Building Permit Application

Description of Work: Eagles Nest - A Elevation - w/ Rear Gathering Room
3 car garage - Opt. Sunroom becomes guest suite w bath (same sf); Finished Basement
12R; 7BR; 6PB; 1HB; fireplace & Walkout
 Seeking Silver Level Certification of the NGBS-3rd party verification by Panda Alliance

PROJECT: REGAN PROPERTY LOT 8

TITLE: BUILDING PERMIT PLAN

RIGHT ELEVATION
W4'-0"

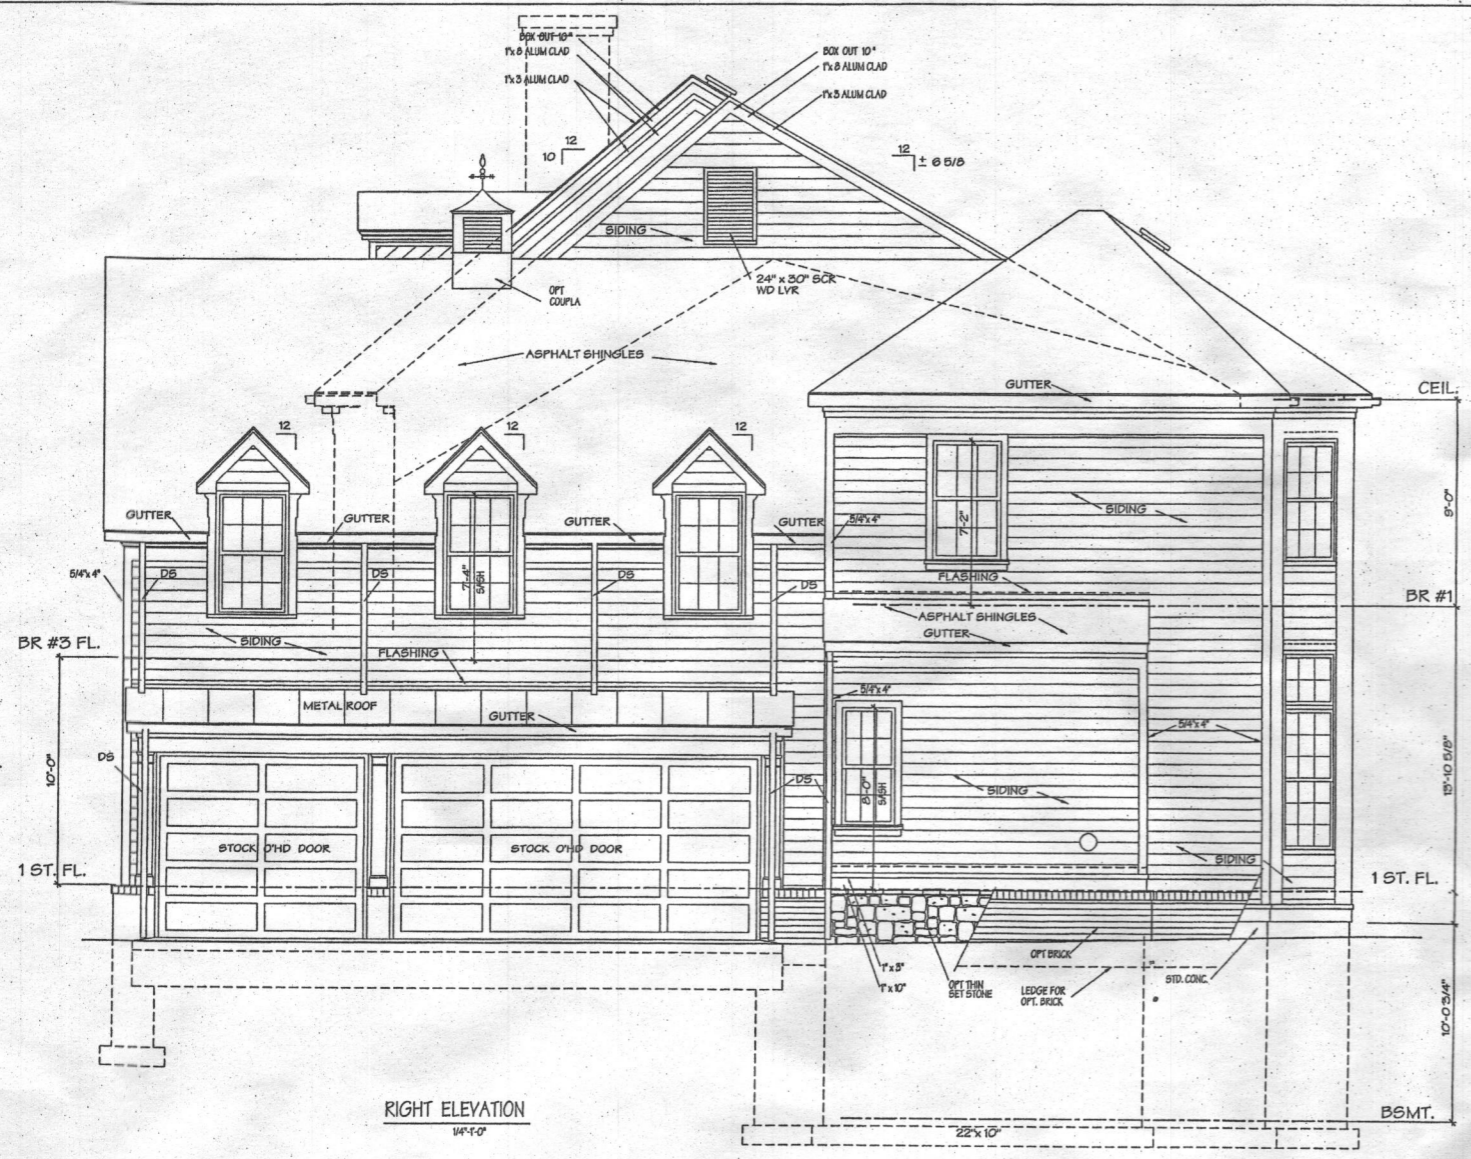
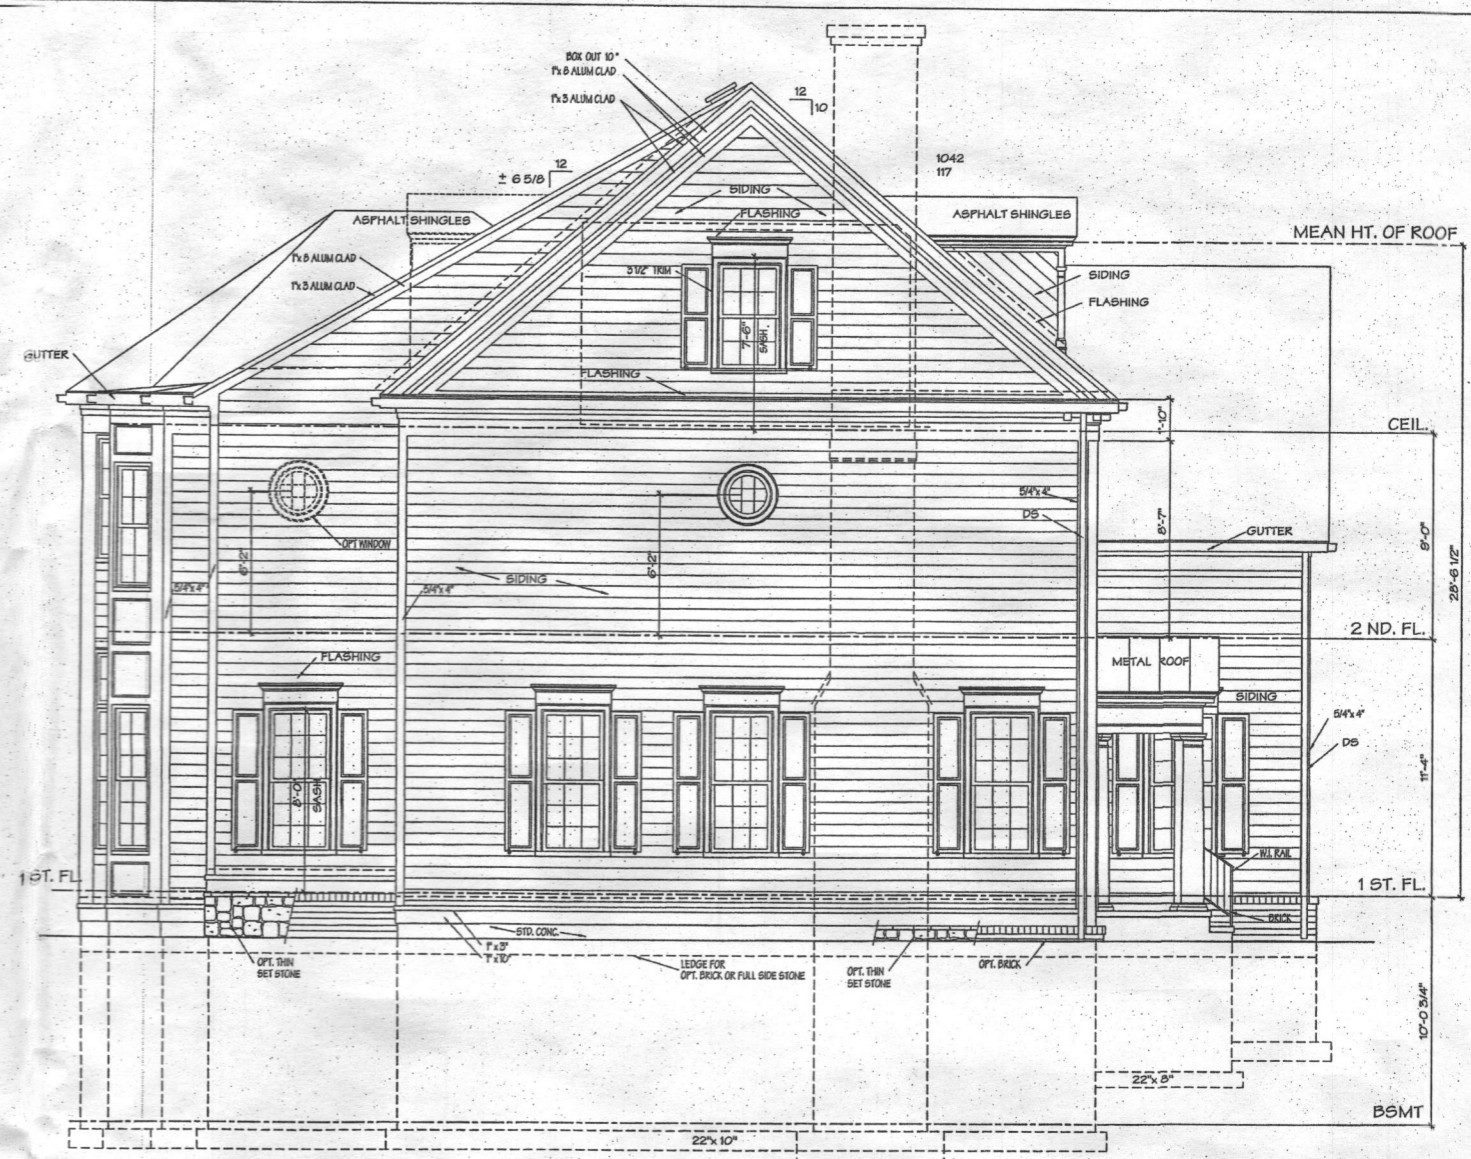
MAKE WALLS 2X6 - LOOSE THE 1 1/2" ON ROOM SIDE OF WALLS AND SHEATH THE STAIR SIDE OF WALL WITH THERMOPLY - NOTE ON PLANS ABOUT THE THERMOPLY

See C Elevation Markups pdf (pg. 3) for use on this Elev. A as well removed ducts from attic

REAR ELEVATION
1440

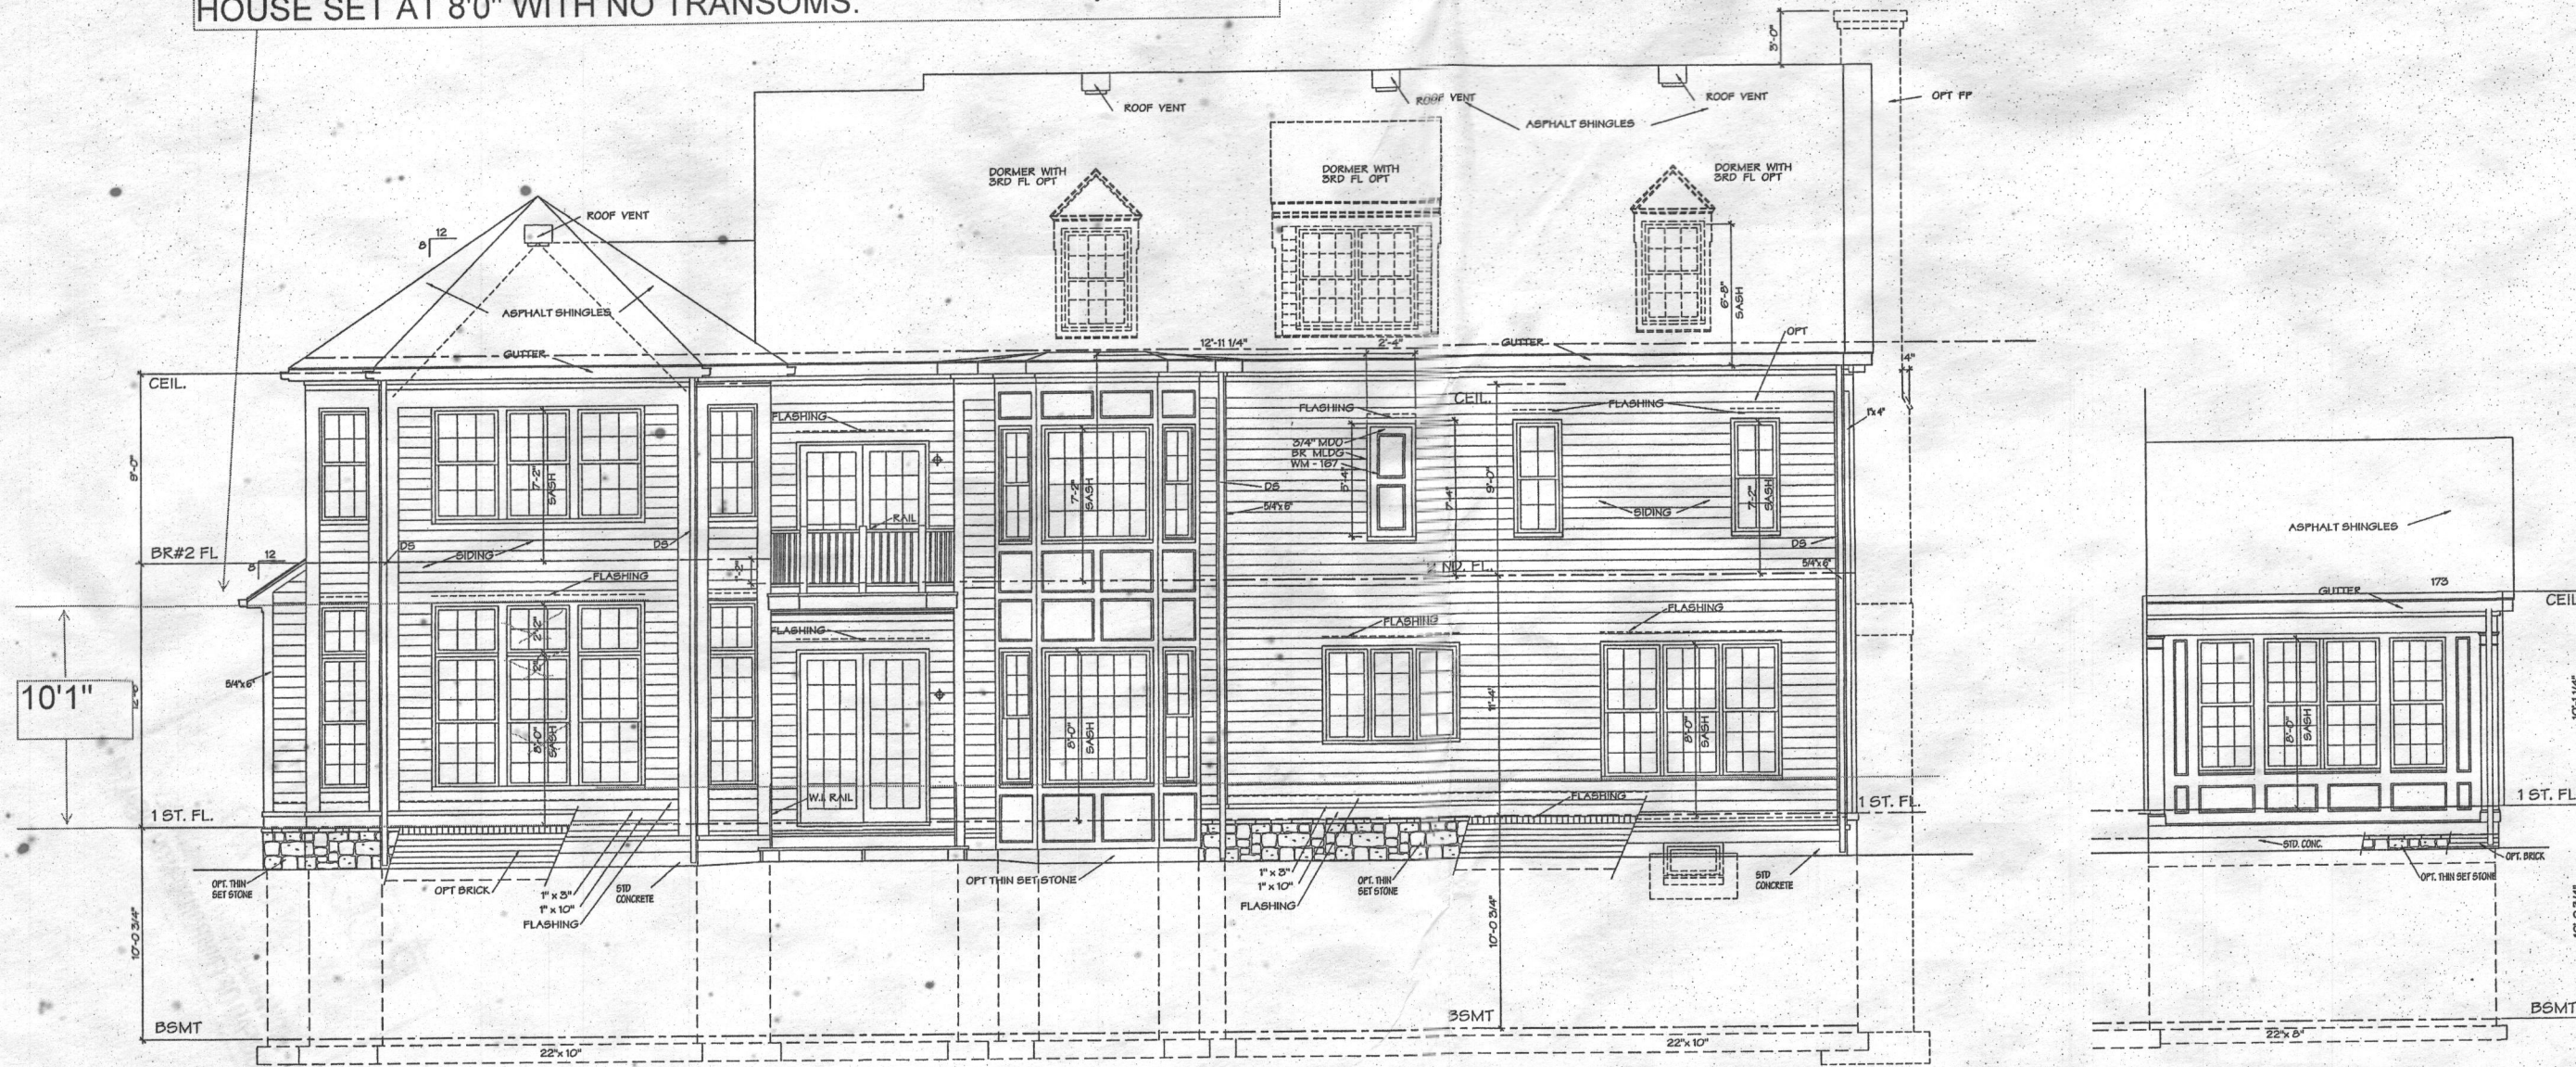
PLEASE REVISE PLAN TO SHOW TOP OF THE 5 FAMILY ROOMS WITH TRANSOMS SET AT 10'1". THIS WILL ALLOW THE SILL OF THESE WINDOWS TO ALIGN WITH OTHER WINDOWS IN THE HOUSE SET AT 8'0" WITH NO TRANSOMS.
